Town of Hilton Head Island Regular Design Review Board Meeting

Tuesday, May 14, 2013
1:15 p.m. – Benjamin M. Racusin Council Chambers

AGENDA

**Town of Hilton Head Island
Design Review Board
Minutes of the Tuesday, April 23, 2013 Meeting
1:15p.m – Benjamin M. Racusin Council Chambers**

OVERALL ELEVATIONS

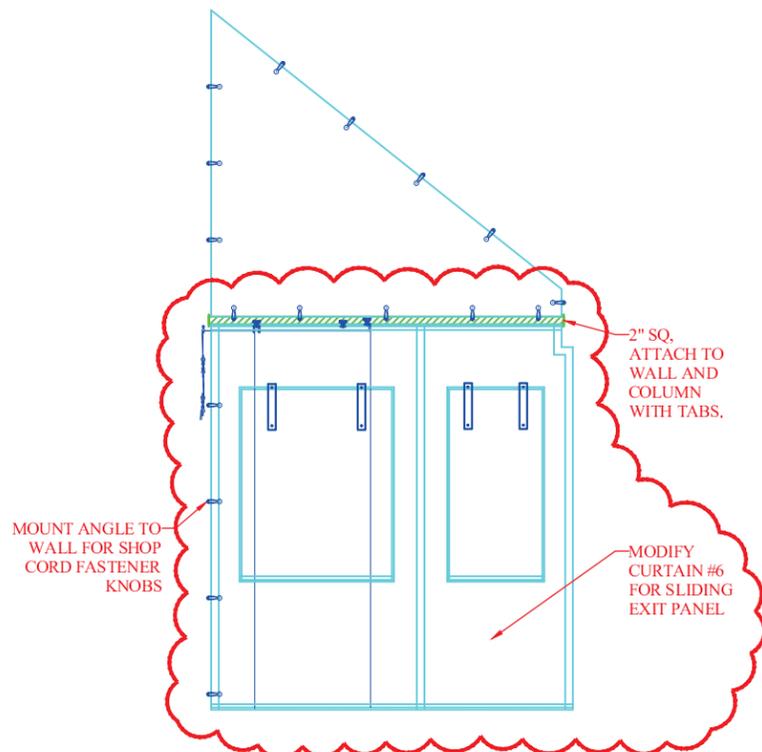
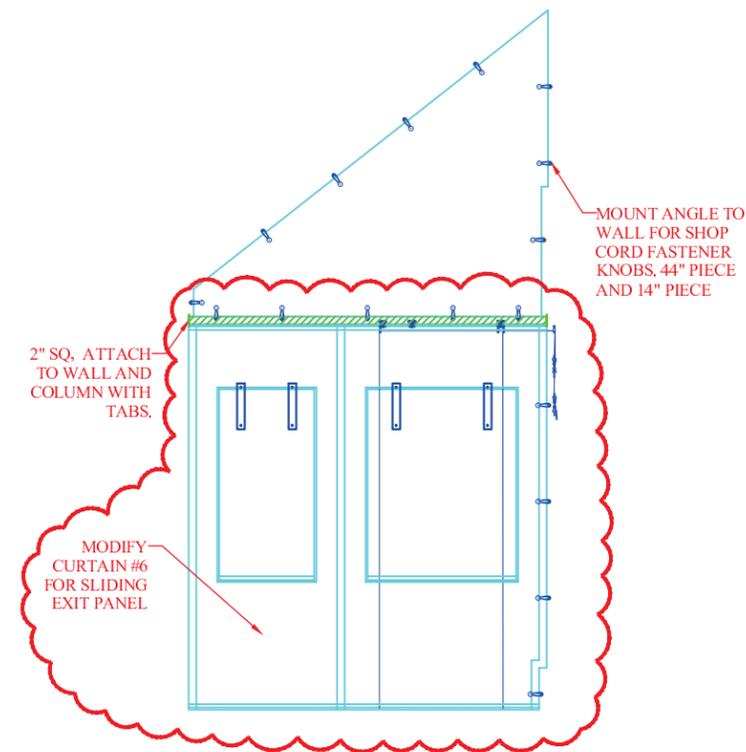
Vine has installed a patio enclosure for the restaurant located in Coligny Plaza. The patio enclosure consists of a permanent hinged door frame and panel as well as fabric curtains that can be drawn up/down depending on the weather. This project was reviewed by the DRB at the February 12, 2013 meeting and withdrawn at the applicant's request. Revised plans include modifying the side panels to provide emergency exists, removing the front door enclosure, and keeping the existing drop-down panels rolled to the top of the handrail.

Staff recommends approval of this application with the condition that an appropriate, complementary color be selected for the side panels.

SLIDING EXIT PANEL
IN CURTAIN #5

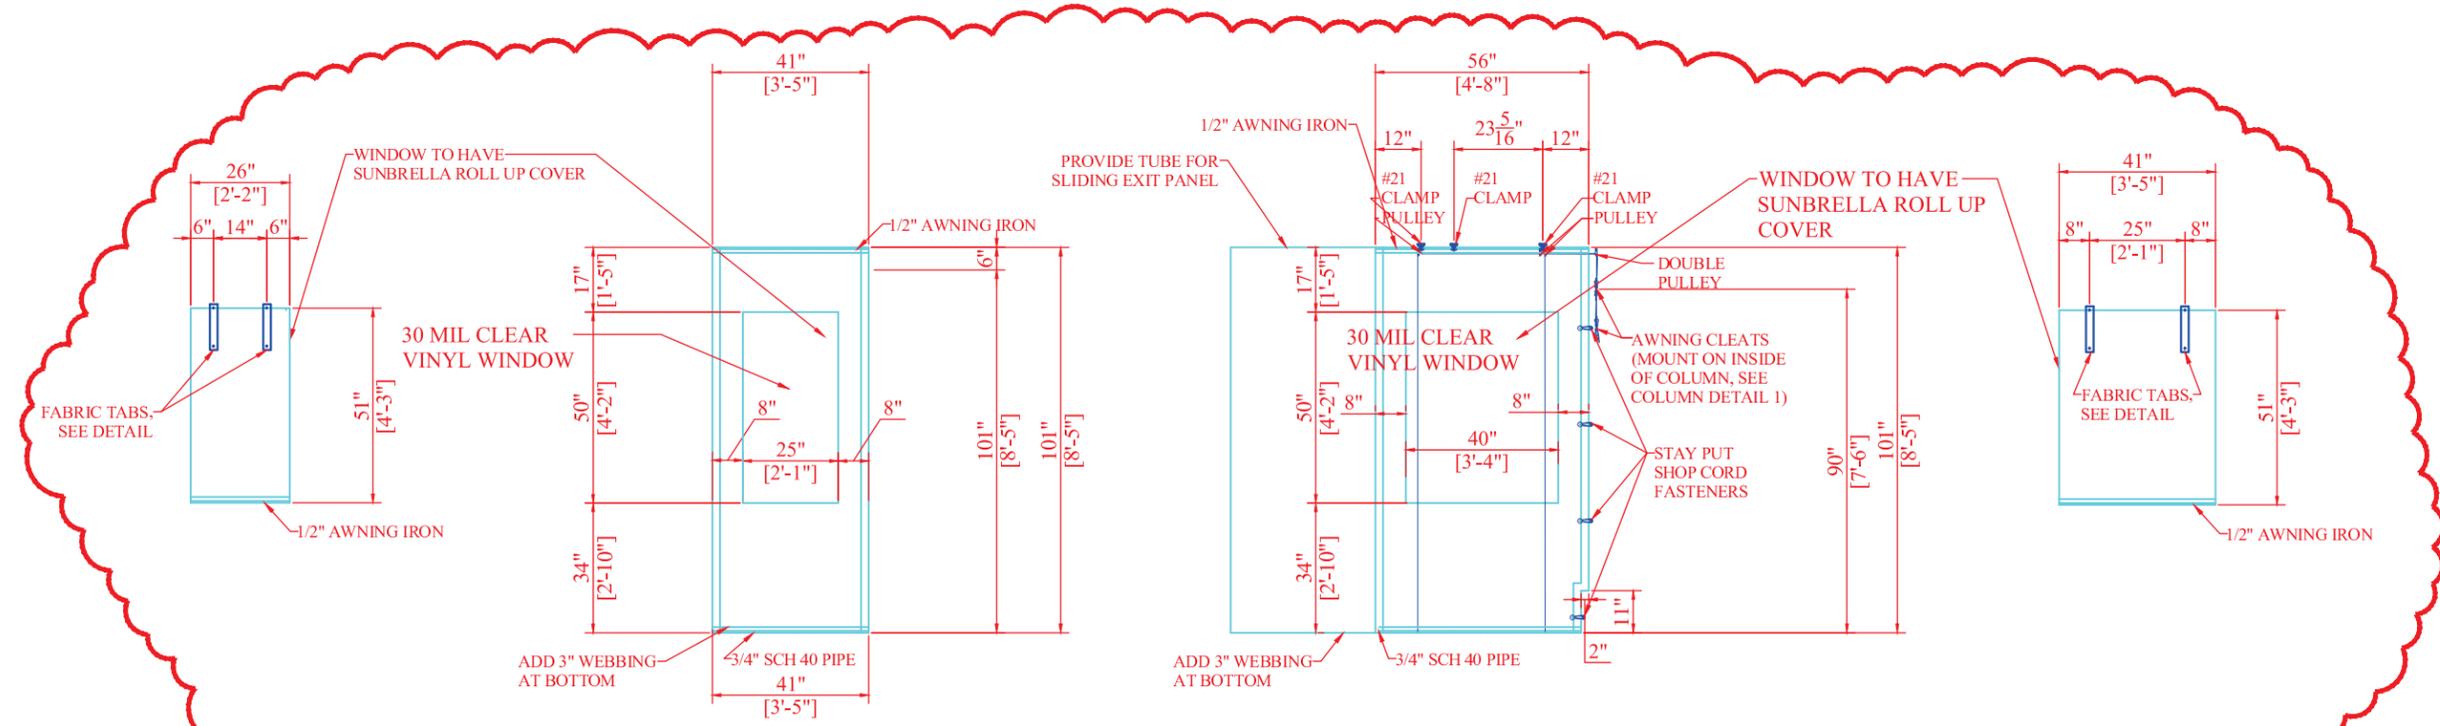
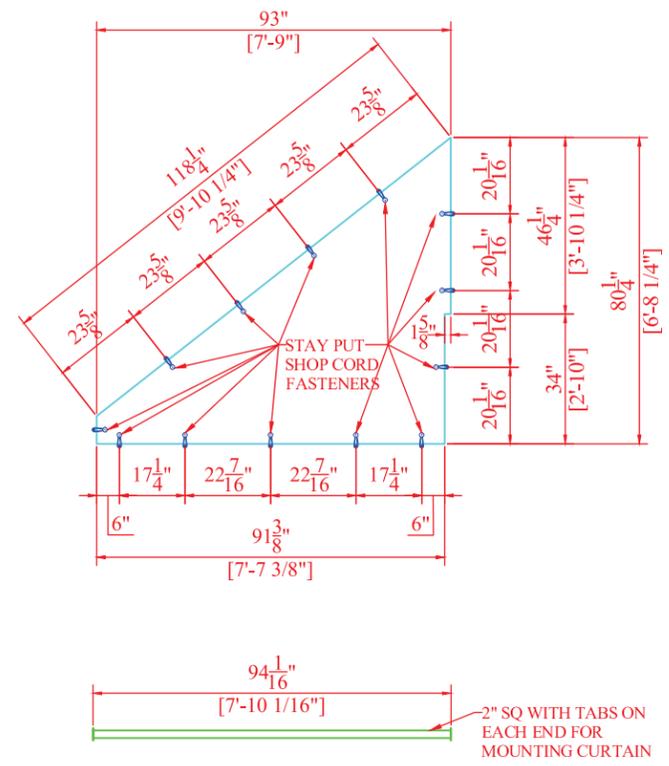
CURTAIN #5
MODIFY CURTAIN #5 AS SHOWN
FOR SLIDING EXIT PANEL

FRONT, SIDE, PLAN
&
ISOMETRIC FRAME VIEW

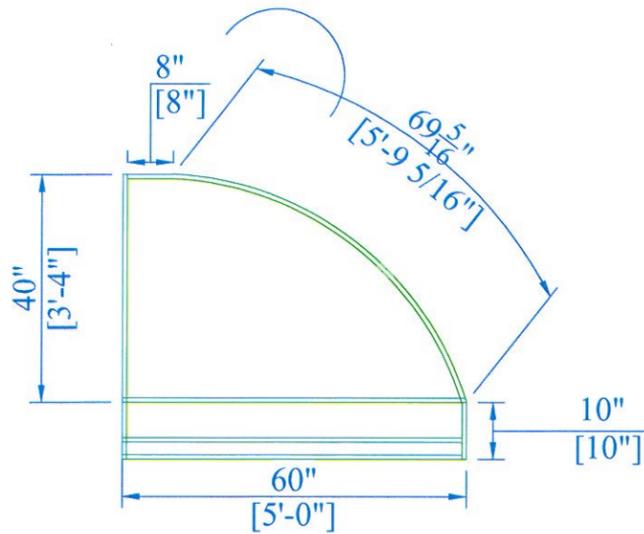
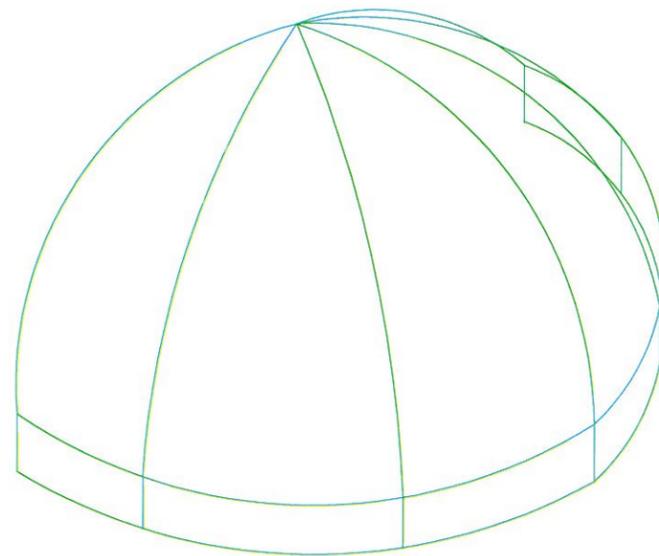
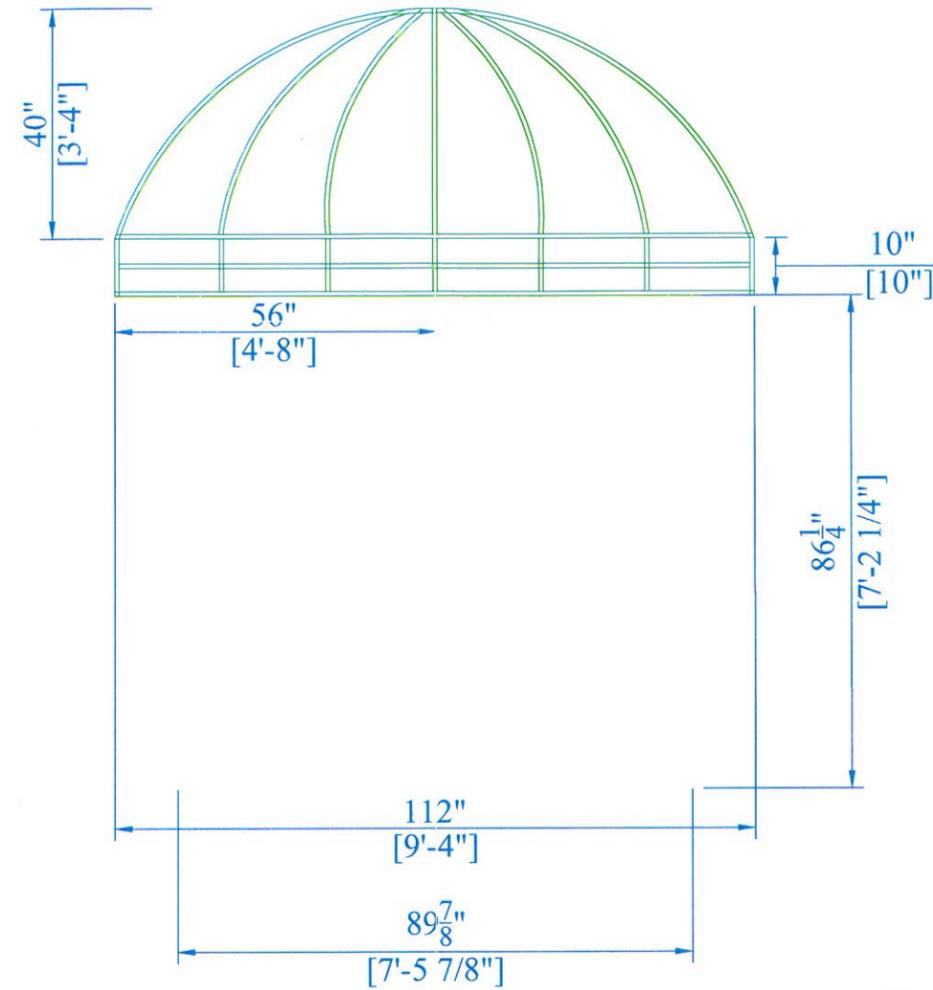
Robert's Jewelers proposes to add a dark green vinyl-coated polyester awning at their Main Street Village location. The shape of the awning (dome) is consistent with other awnings in Main Street (both dome and traditional); however, most awnings over double doors are traditional. The color is consistent with the existing hanging sign (which is in need of repainting). An alternate color (i.e. black) would be more in keeping with the building color (blue-gray).
